REQUEST

Current Zoning: N1-A (neighborhood 1-A)
Proposed Zoning: R-8(CD) (residential, conditional)

Approximately 24.96 acres located on the south side of Allen Road East and east side of Citadel Place, west of Allen Road South.

PLANNING STAFF REVIEW

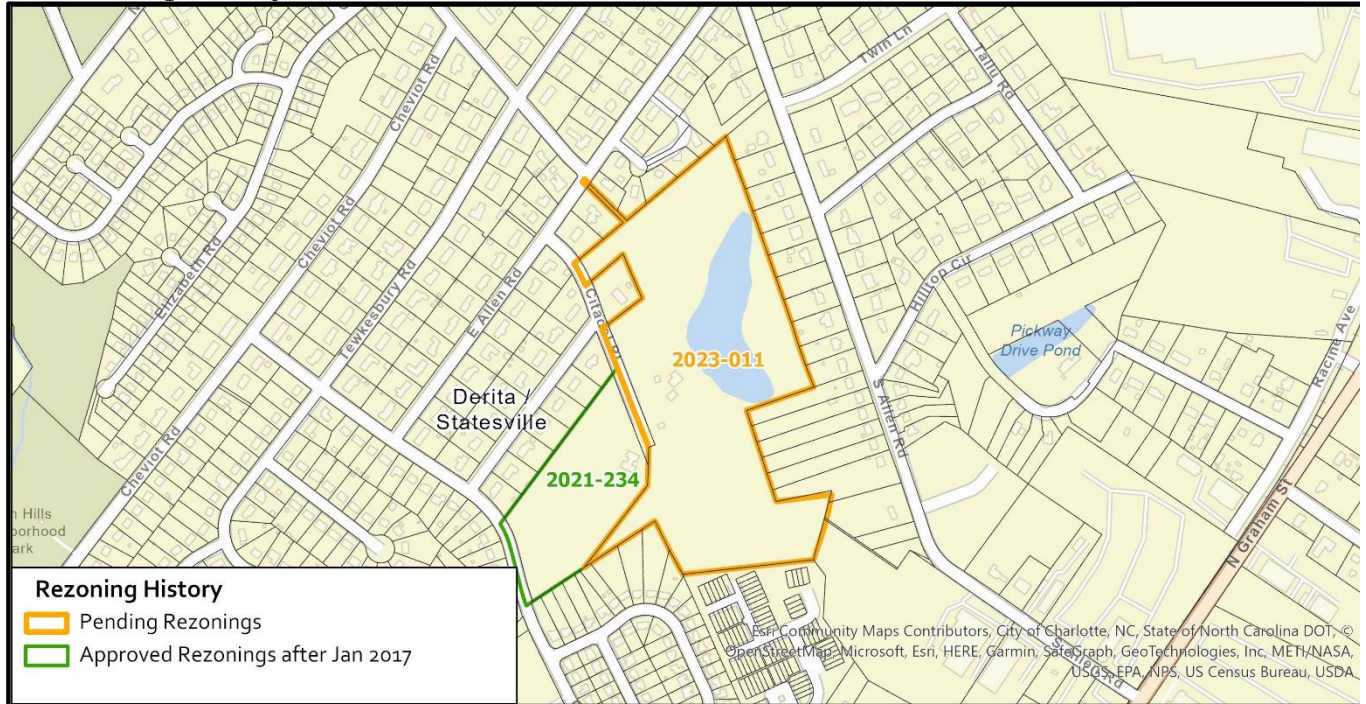
- ~~1. Reduce unit count and incorporate a mix of buildings that better align with the N1 Place Type (duplexes, triplexes).~~ Addressed
- ~~2. Relocate proposed dumpster location away from existing houses.~~ Addressed
- ~~3. Add visitor parking areas.~~ Addressed

- ~~4. Revise the park note to read: "land to be dedicated and conveyed to Mecklenburg County."~~ Addressed

- Allows up to 84 80 dwelling units in a townhouse style.
- Proposes duplexes and triplexes.
- Trash pick-up will be provided by roll-out carts.
- Provided a wetlands clarification letter.
- Provides an 8-foot planting strip and 6-foot sidewalk along the site's frontage on Citadel Place.
- Provides an 8-foot planting strip and 6-foot sidewalk on all internal streets.
- Provides a 30-foot right-of-way along Citadel Place from the centerline of the road.
- Dedicates a minimum 1.25 0.80 acres to Mecklenburg County for a future neighborhood park.
- Provides architectural standards.
